# HISTORIC AND DESIGN REVIEW COMMISSION

February 17, 2021

**HDRC CASE NO:** 2021-020  
**ADDRESS:** 231 W AGARITA AVE  
**LEGAL DESCRIPTION:** NCB 3261 BLK 7 LOT 8 & W 20 FT OF 9  
**ZONING:** R-5, H  
**CITY COUNCIL DIST.:** 1  
**DISTRICT:** Monte Vista Historic District  
**APPLICANT:** Gregory Papay/PAPAY GREGORY S & EVA  
**OWNER:** Gregory Papay/PAPAY GREGORY S & EVA  
**TYPE OF WORK:** Roof replacement, gutter replacement, remove rear dormers  
**APPLICATION RECEIVED:** January 12, 2021  
**60-DAY REVIEW:** Not applicable due to City Council Emergency Orders  
**CASE MANAGER:** Rachel Rettaliata

1. Replace the existing asphalt shingle roof with a standing seam metal roof
2. Remove the non-original dormers at the north (rear) side of the house to restore the simple hip profile to the roof.

ROOF PLAN

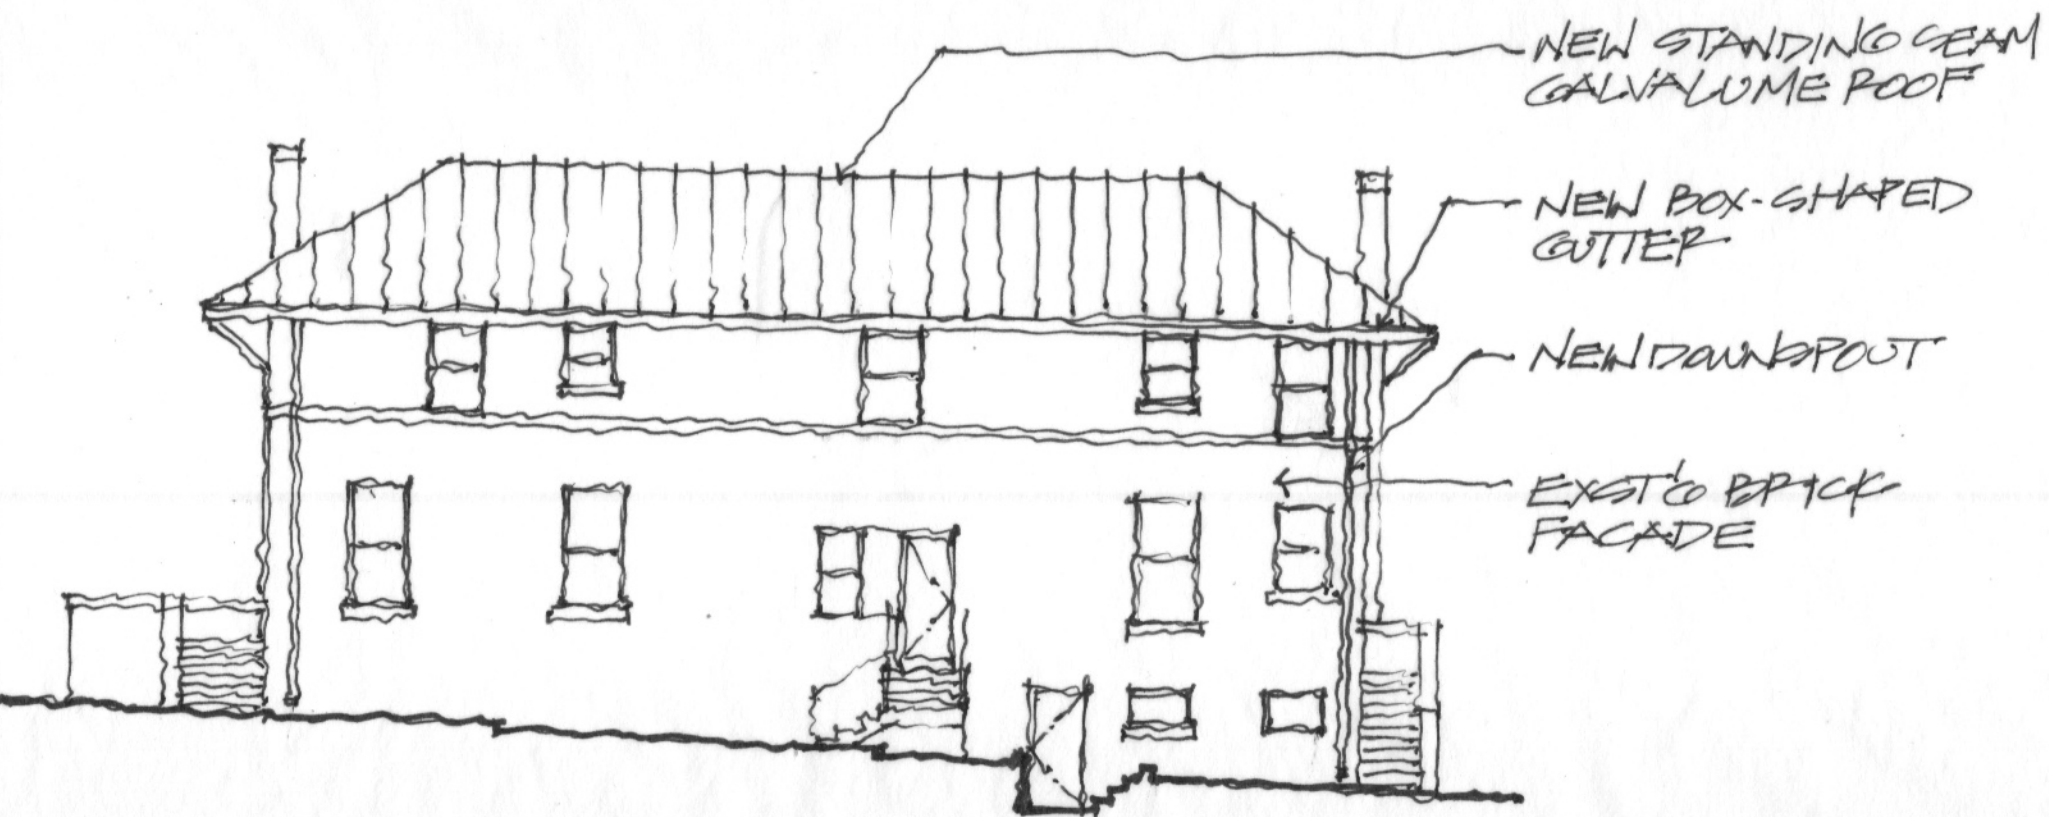
- b. ROOF REPLACEMENT – The applicant is requesting approval to replace the existing asphalt shingle roof with a standing seam metal roof with galvalume finish to match the existing roofing of the carriage house. The applicant has proposed to install a standing seam metal roof with a double-munch ridge configuration. According to Guideline 3.B.iv for Exterior Maintenance and Alterations, metal roofs can be used on structures that historically had a metal roof or where a metal roof is appropriate for the style of the construction period. According to the 1951 Sanborn map, the structure originally featured a roof covering of metal, slate, tile, or asbestos shingles. Staff finds the proposal appropriate.

- i. That the applicant installs a standing seam metal roof featuring panels that are 18 to 21 inches wide, seams that are 1 to 2 inches high, a crimped ridge seam, and a standard galvalume finish. Ridges are to feature a double-munch or crimped ridge configuration; no vented ridge caps or end caps are allowed. An on-site inspection must be scheduled with OHP staff prior to the start of work to verify that the roofing material matches the approved specifications. All chimney, flue, and related existing roof details must be preserved.

NORTH ELEVATION - DEMO  
231 WEST AGARITA

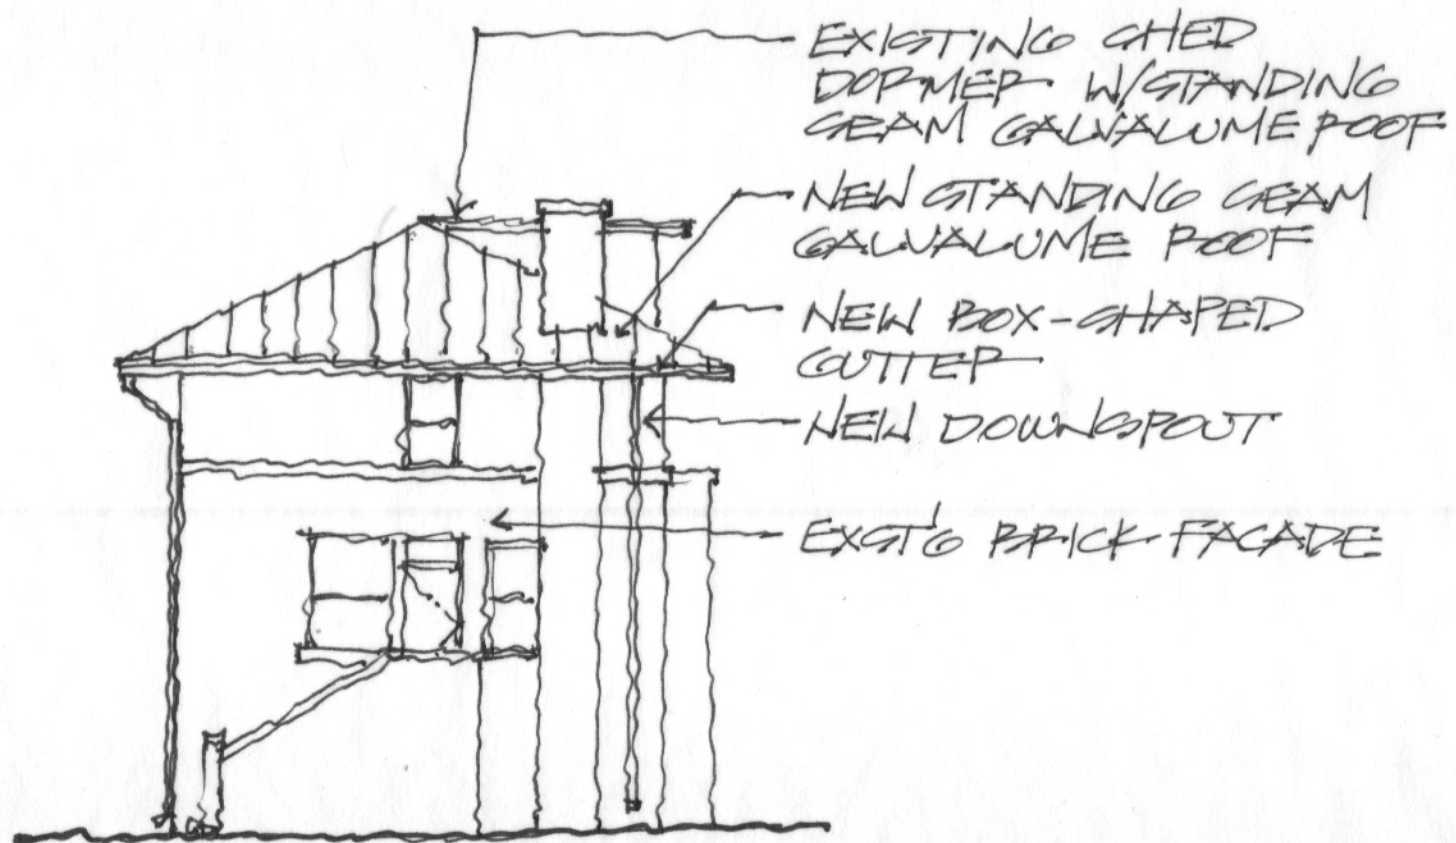
- c. DORMER REMOVAL – The applicant has proposed to remove the gable dormers located on the north side (rear) of the roof in order to restore the simple hip roof profile of the roof. Guideline 3.B.ii for Exterior Maintenance and Alterations stipulates that the original shape, line, pitch, and overhang of historic roofs should be preserved when replacement is necessary. The existing dormers are likely non-original elements and removing the dormer would preserve the original roof form. Staff finds the proposal appropriate.

Item 2, staff recommends approval of the rear dormer removal based on finding c.
